LANDSCAPE PLANS APPROVED

LANDSCAPING PLAN
(A1) 1:200

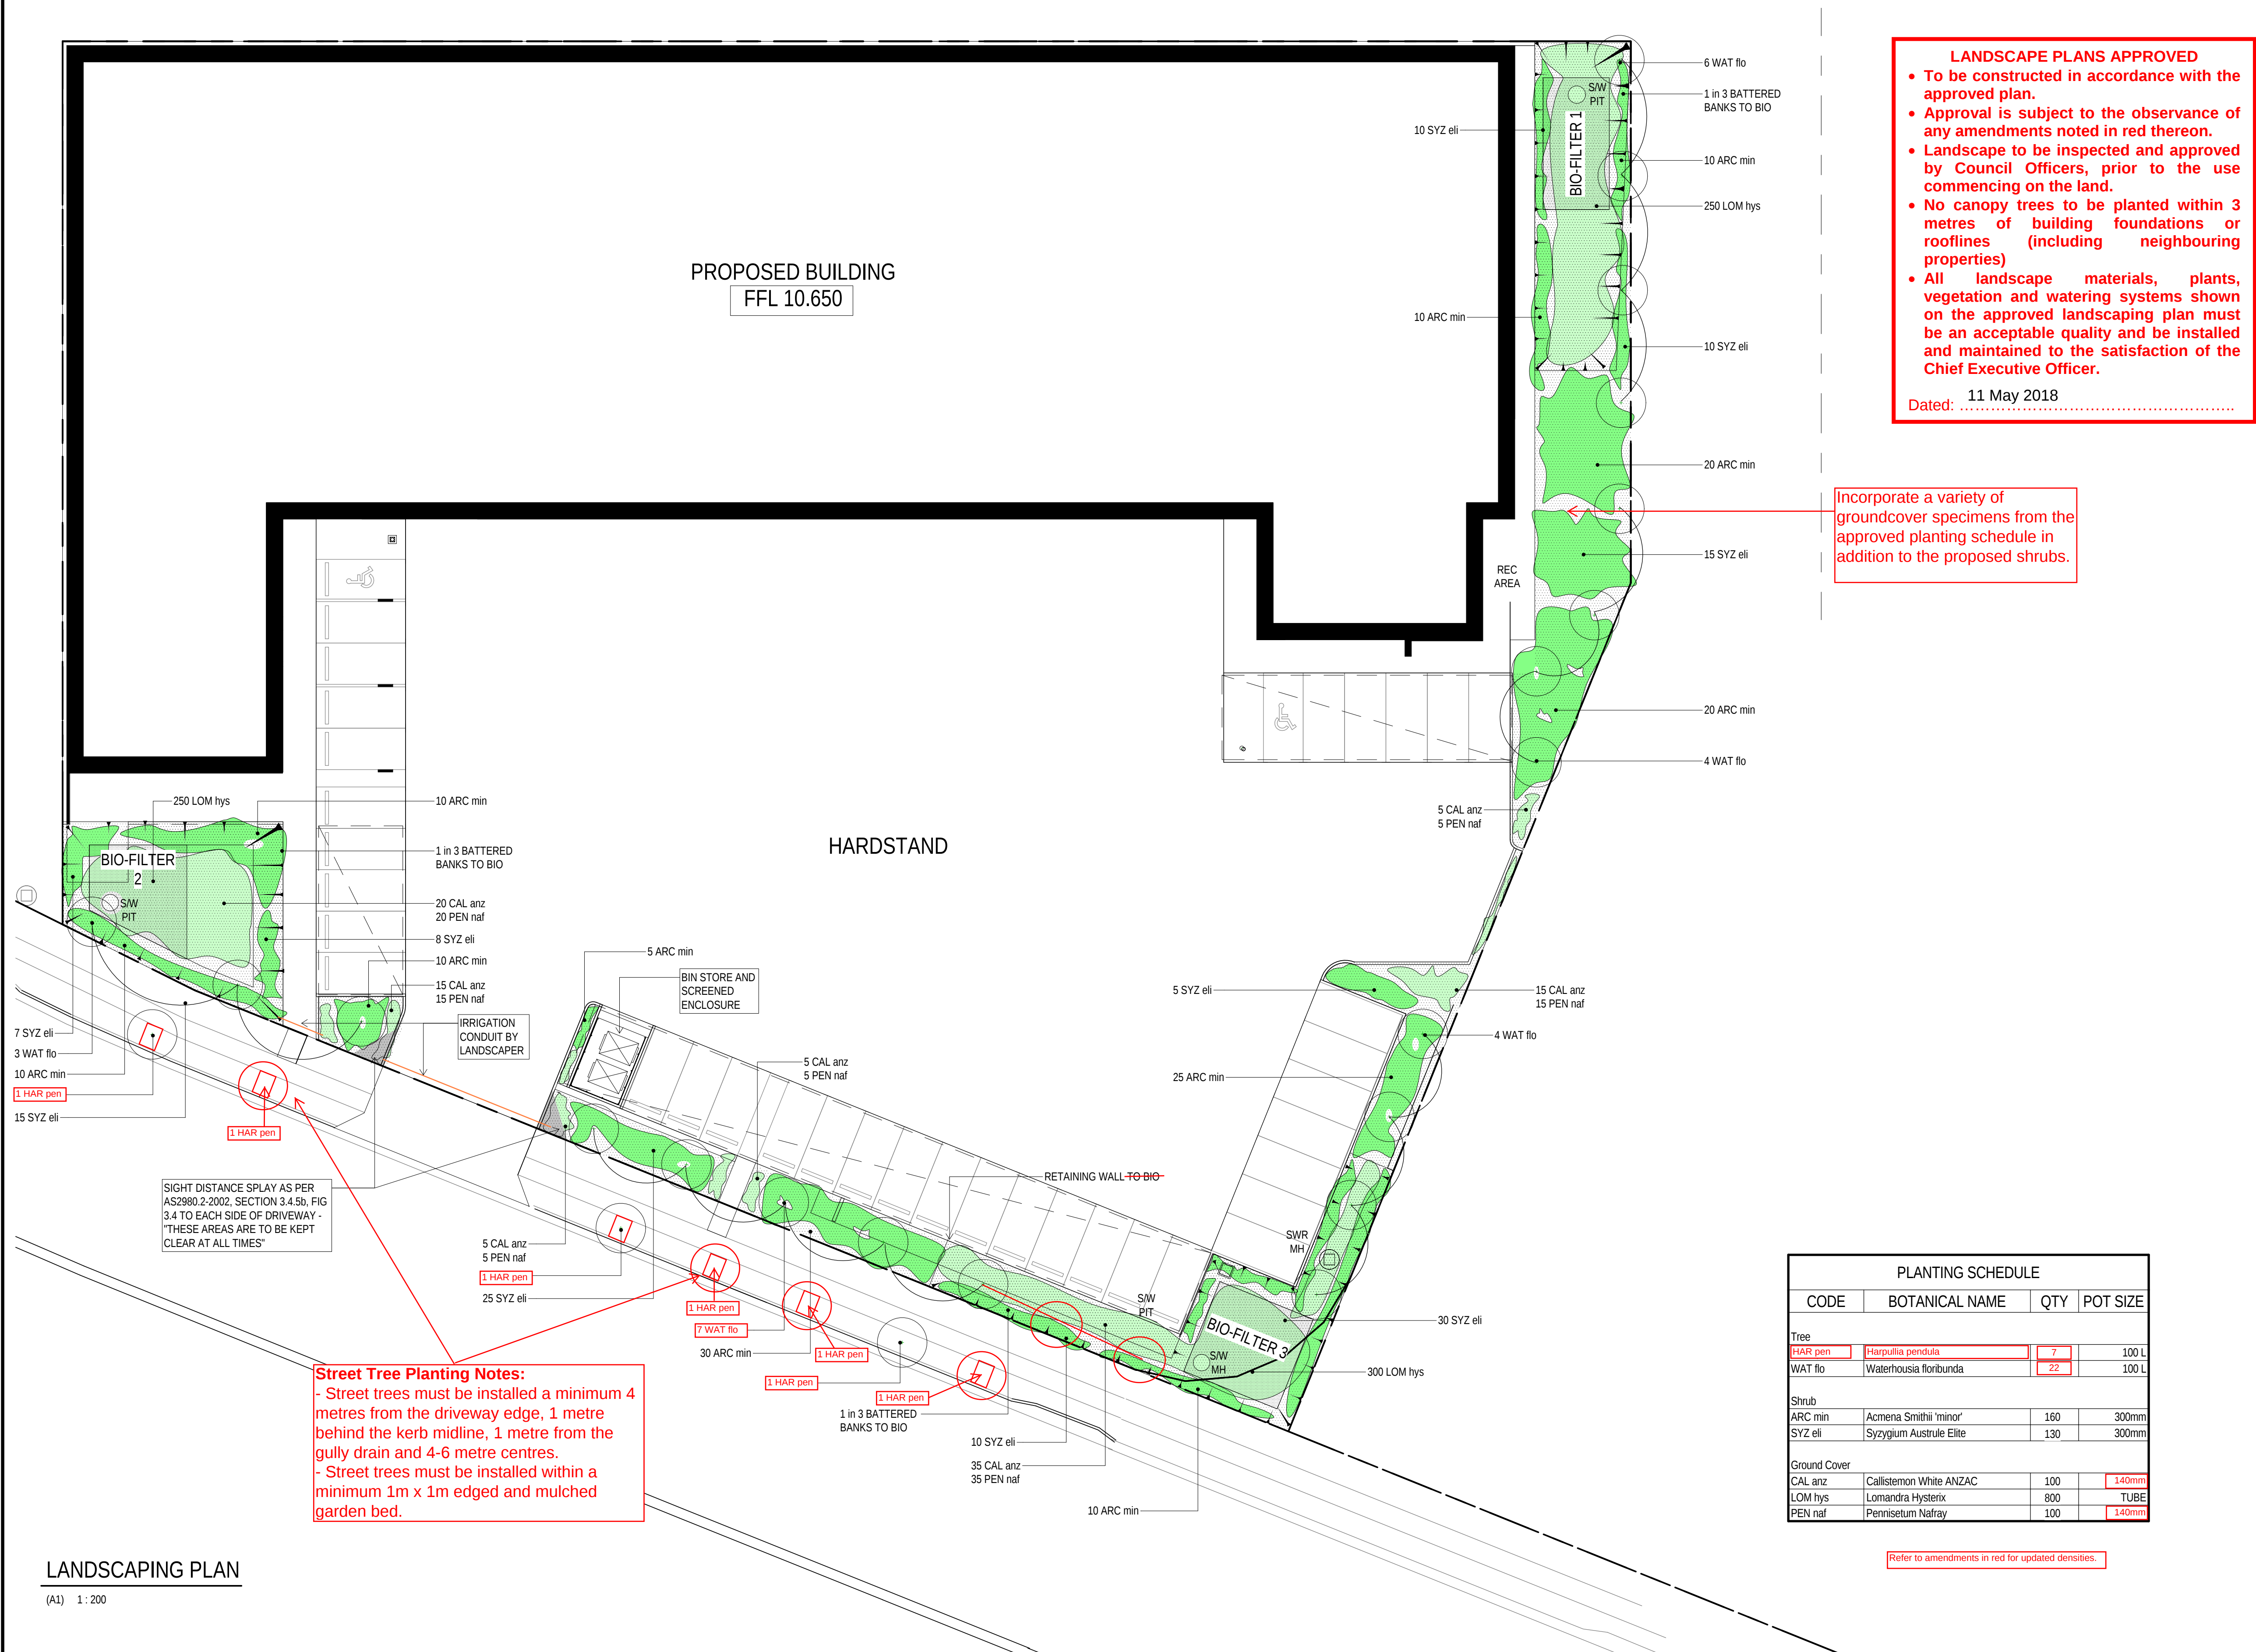
Incorporate a variety of groundcover specimens from the approved planting schedule in addition to the proposed shrubs.

Refer to amendments in red for updated densities.

- All under sized or poor quality stock will be required to be replaced prior to inspection approval.
- Existing Street trees to be retained and protected. Damaged street trees to be replaced with minimum 100l bag size, staked, mulched and edged as per GCCC street tree planting - setout guidelines

- Street trees to be, staked, mulched and edged as per GCCC street tree planting - setout guidelines. Must be setback a minimum 3m from the proposed driveway and 1m setback from the nominal kerb line.

- All road reserve turf must be repaired or replaced if damaged.
- All trees must be staked, edged and mulched.
- Ensure all proposed trees within the private lot are setback 3m minimum from the proposed roof line or building foundations.

- All planting to be within an edged and mulched garden bed complying with the City Plan Policy - Landscape Work.
- All nursery bamboo stakes and plastic/rubber ties must be removed from planted tree specimens before final inspection.

- Basins - If there is a vertical fall of more than 500mm from the carpark edge to the edge of the tree basin floor, ensure that a loose rock (75mm diameter minimum to 200mm diameter maximum) batter is installed at a grade of 1:1.

- Trees (only small trees) within the 2-3 metre setback from proposed roof line or building foundations, but must use a root barrier.
